UNITED STATES PATENT AND TRADEMARK OFFICE

APPLICATION NO.	FILING DATE	FIRST NAMED INVENTOR	ATTORNEY DOCKET NO.	CONFIRMATION NO.
09/550,596	04/17/2000	Mauro Bettiai	10138-0002-2	1077
7590	08/12/2004		EXAMINER	
U P Peter Eng Wilson Sonsini Goodrich and Rosati 650 Page Mill Road Palo Alto, CA 94304			RODRIGUEZ, ARMANDO	
			ART UNIT	PAPER NUMBER
				2828

Office Action Summary	Application No.	Applicant(s)
	09/550,596	BETTIATI ET AL.
Examiner	Art Unit	
ARMANDO RODRIGUEZ	2828

DETAILED ACTION

FIG. 12

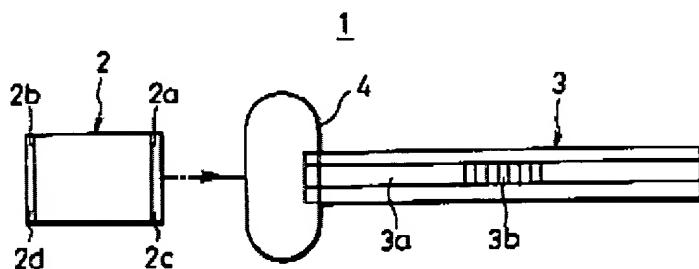
Mugino et al illustrates in figure 12 a semiconductor laser module having a semiconductor laser (2) with a reflecting surface (2b), an emitting surface (2a) and an optical fiber (3) including a fiber grating (3b), as described in column 9 lines 20-35 and column 10 lines 50-55. In column 3 lines 58-65 and column 10 lines 43-49, Mugino et al describes the semiconductor laser having central wavelength and the fiber grating

having a central wavelength, where the difference of the wavelengths is + or – 20nm or less, which clearly encompass the claimed difference in wavelength of 10nm. In column 11 lines 18-37, discloses the operating the laser at different temperatures including 25°C, which is considered ambient temperature.

Figure 12 does illustrate an optical fiber (3).

Figure 12 does illustrate an optical fiber (3) with a Bragg grating (3b).

FIG. 1

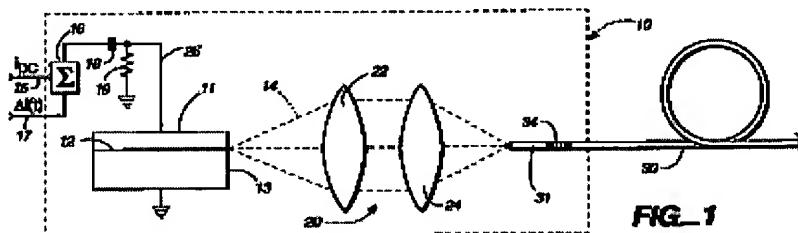
Mugino et al does not disclose the use of a collimating lens and a focusing lens.

However, the use of optical elements for coupling laser radiation is well known in the art, as shown by Ventrudo. Figure 1 illustrates a pigtailed laser diode having a collimating lens (22) and a focusing lens (24) for coupling the laser diode radiation to the optical fiber.
